Capital Area Transportation Authority

AMENDMENT OF SOLICITATION

1. AMENDMENT NO: 2	2. SOLICITATION NO: 2014-R06	3. SOLICITATION DATE: 28 AUG 2014	4. EFFECTIVE DATE: 22 SEP 2014
-----------------------	---------------------------------	--------------------------------------	-----------------------------------

Subject: CATA Response to Questions on RFP 2014-R06, Access Control System

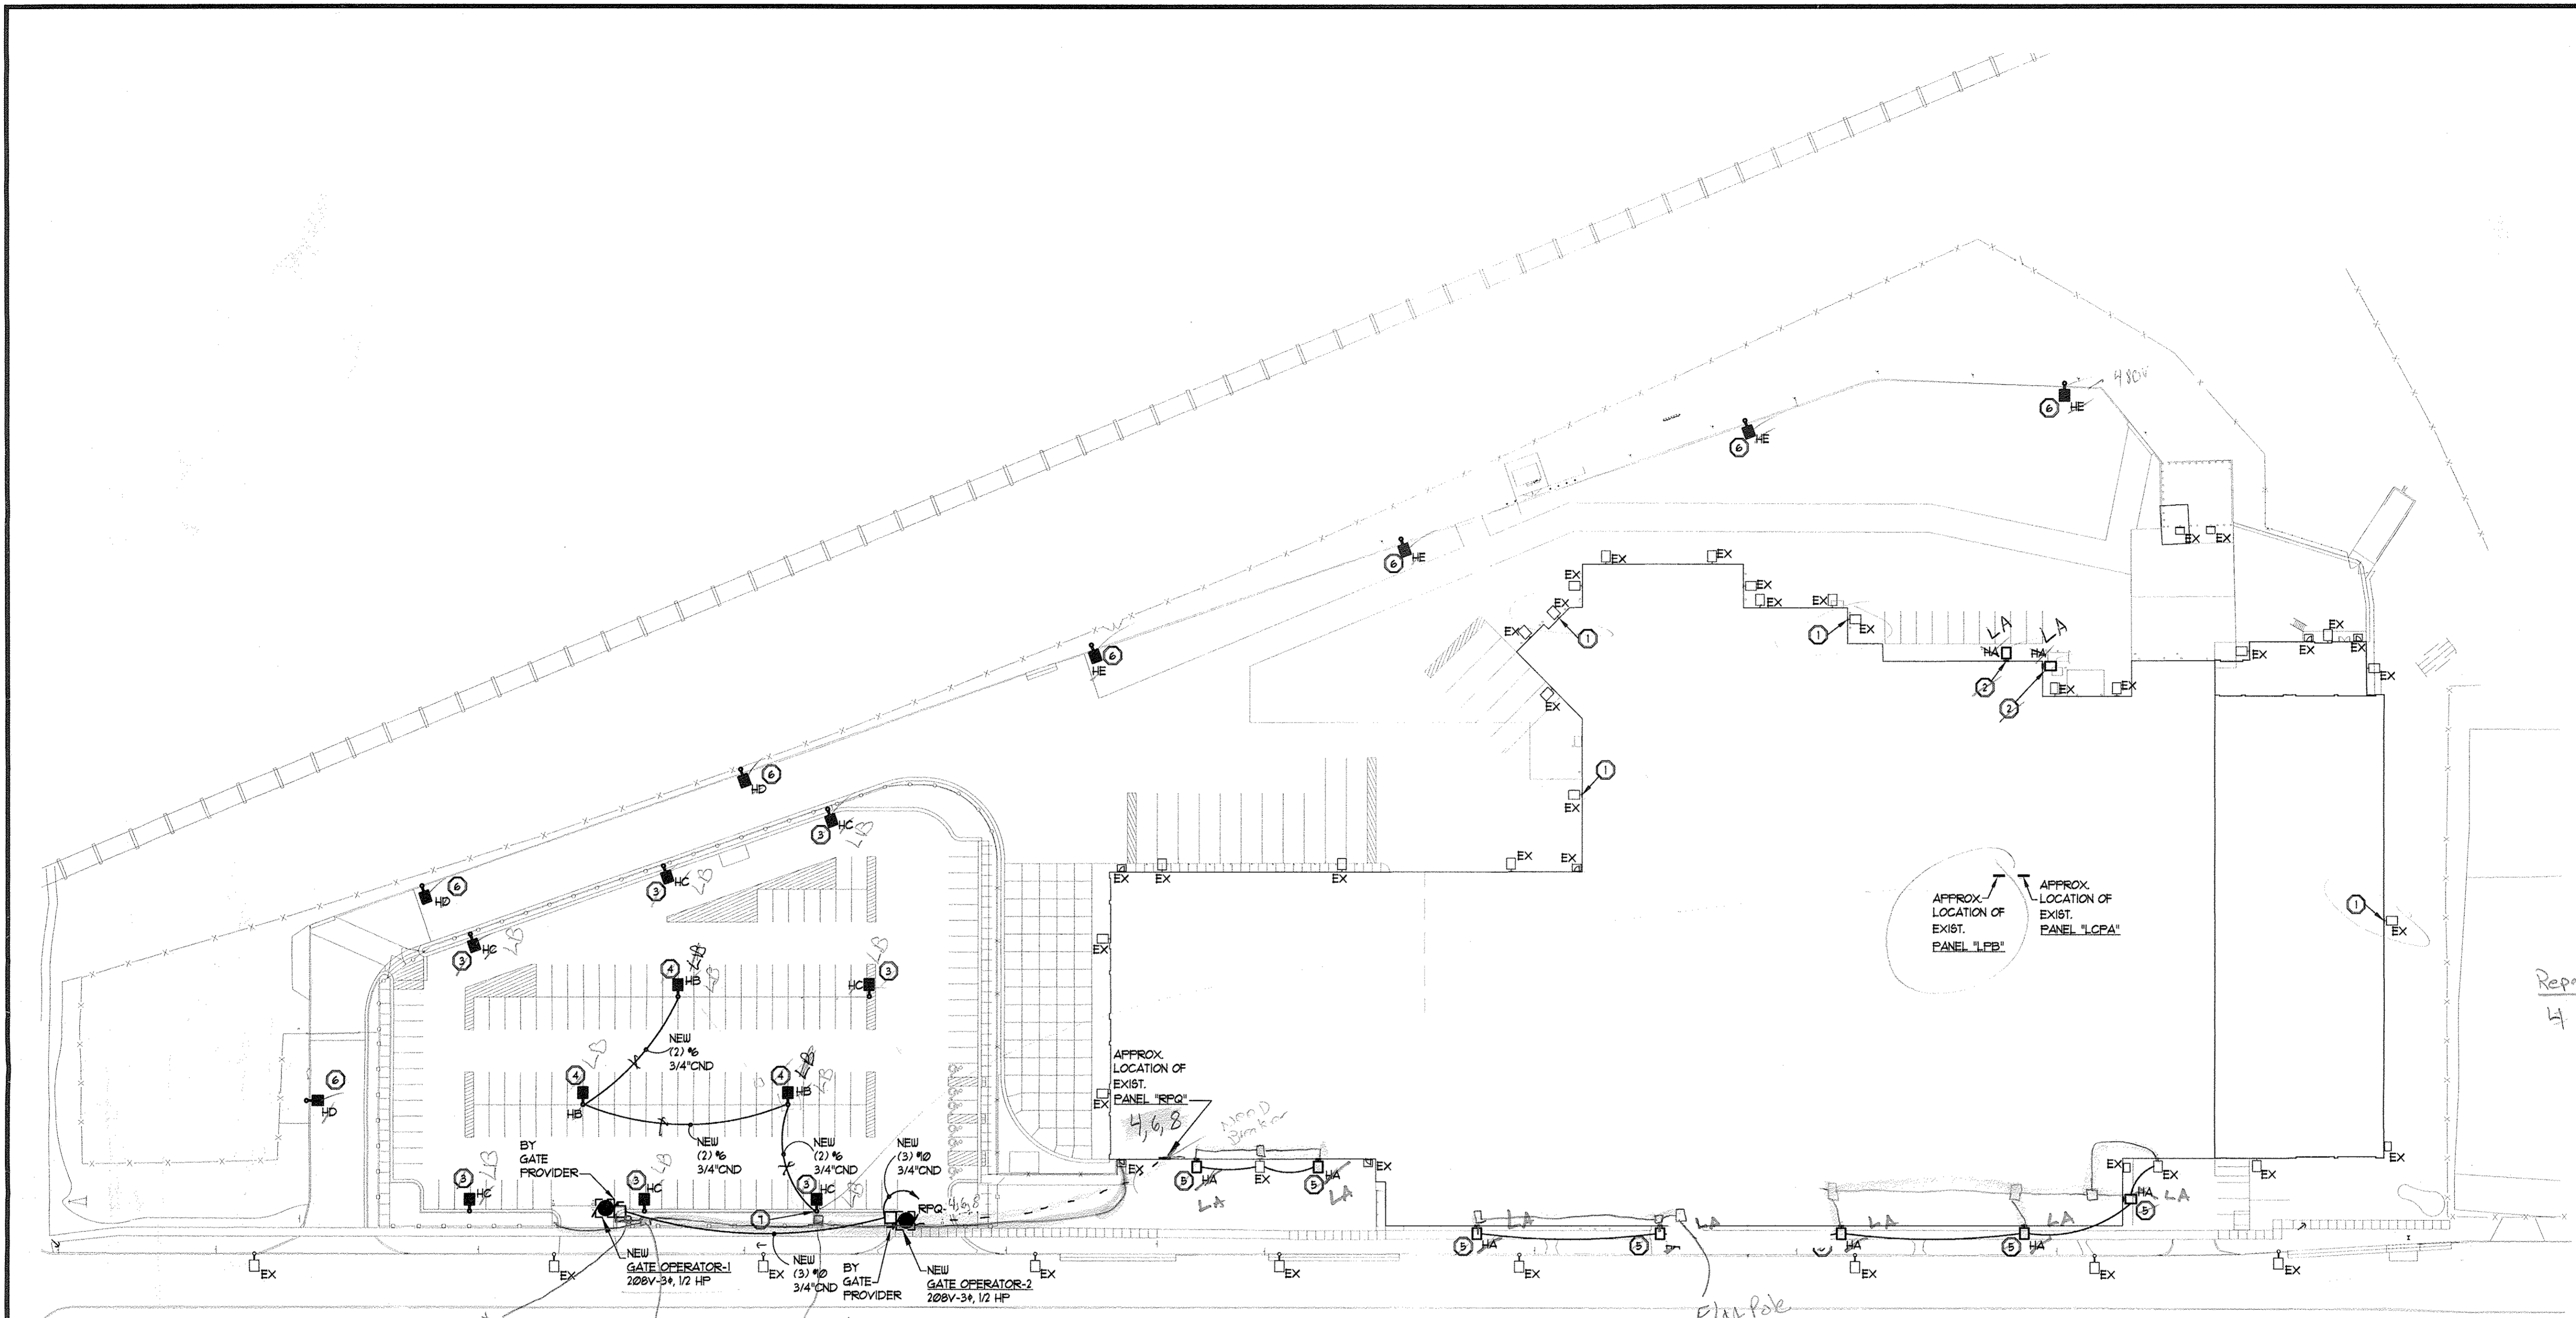
15. Could you please provide a model or part number for the existing ego tags? If not, could you please post a picture of the existing tags?

CATA Response: TransCore eGo Plus Sticker Tag
